HIDDEN OAKS  
SAN ANTONIO TEXAS

# CITY OF SAN ANTONIO

Re: Hidden Oaks ☒ Preliminary Plan  
☐ P.O.A.D.P.  
File #: 84-11-62-40

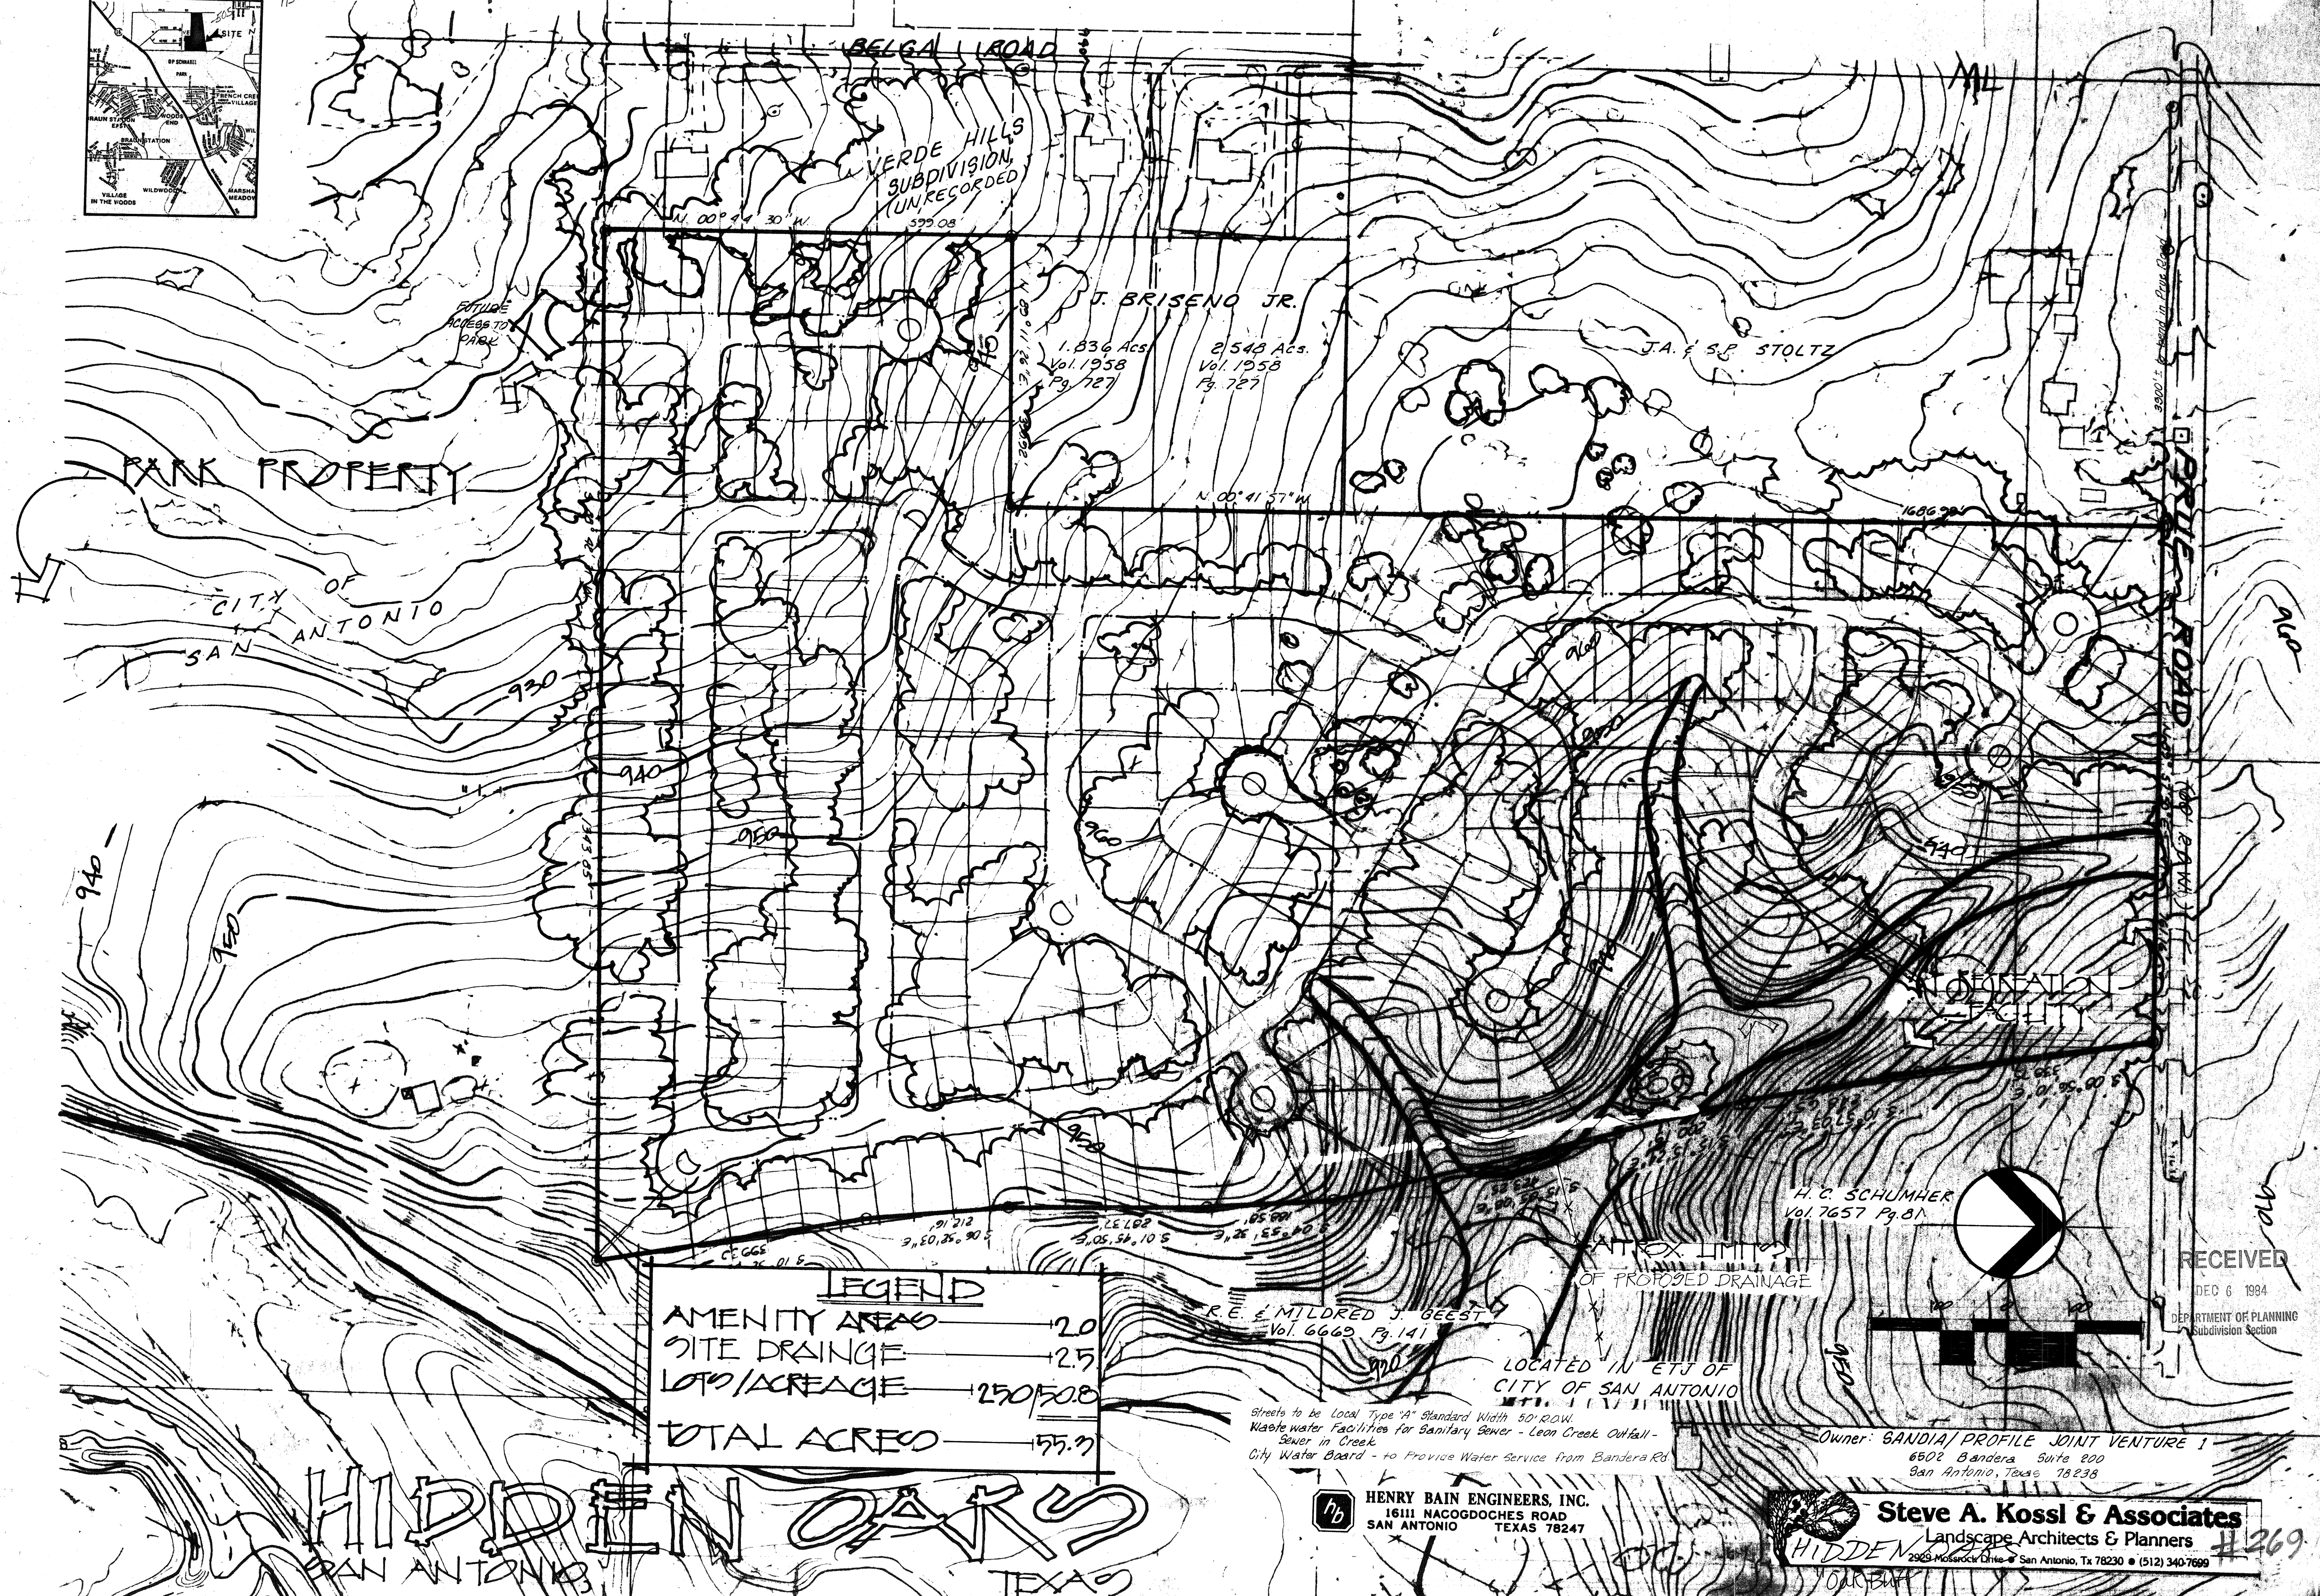
Based on your proposal and expected development to the east, it is recommended that the entry street at Prue and its most easterly continuation be upgraded to a collector standard. The collector should be designed to stub into the Geest tract as generally shown on the attached P.O.A.D.P. Additionally we recommend that the orientation of lots be positioned in a fashion to side or backup instead of fronting onto the collector. This, coupled with the upgrading of the street to a collector status, will facilitate traffic movement and future development in the immediate area.

In regards to access into park property, it will be necessary for you to work with Dale Bransford of the City Parks and Recreation Department. In reviewing planned access to the park, representatives from the parks department have indicated they do not concur to the access location being proposed.

If you agree with staff's recommendation please resubmit your P.O.A.D.P. with the changes. However, if you believe this matter should be further discussed we will be glad to meet with you.
